## **PUBLIC WORKS COMMITTEE**

- Item 2 Approval of Change Order No. 2 to the Agreement between the City of Coeur d'Alene and Apollo, Inc. for Construction of the Wastewater Tertiary Treatment Phase 2 Improvements – Mike Becker, WW Capital Program Manager

**DATE:** September 23, 2019  
**FROM:** Mike Becker, Capital Program Manager  
**SUBJECT:** Approval of Change Order No. 2 to the Agreement between the City of Coeur d'Alene and Apollo, Inc. for Construction of the Wastewater Tertiary Treatment Phase 2 Improvements

Date of Issuance: September 13, 2019  
Owner: City of Coeur d'Alene Wastewater Department  
Contractor: Apollo, Inc.  
Engineer: HDR  
Project Name: Coeur d'Alene Tertiary Treatment  
Phase 2

Corrosion Issues

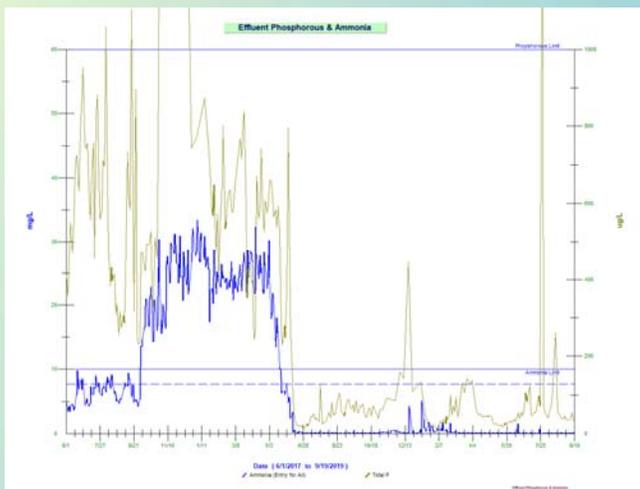
While working to remove piping in the TMF, corrosion was discovered on the existing valves. These valves identified will need to be replaced with new valves that have stainless steel for the disc and body and Buna-N or EPDM for the seat. Exhibits identifying these valves are provided.
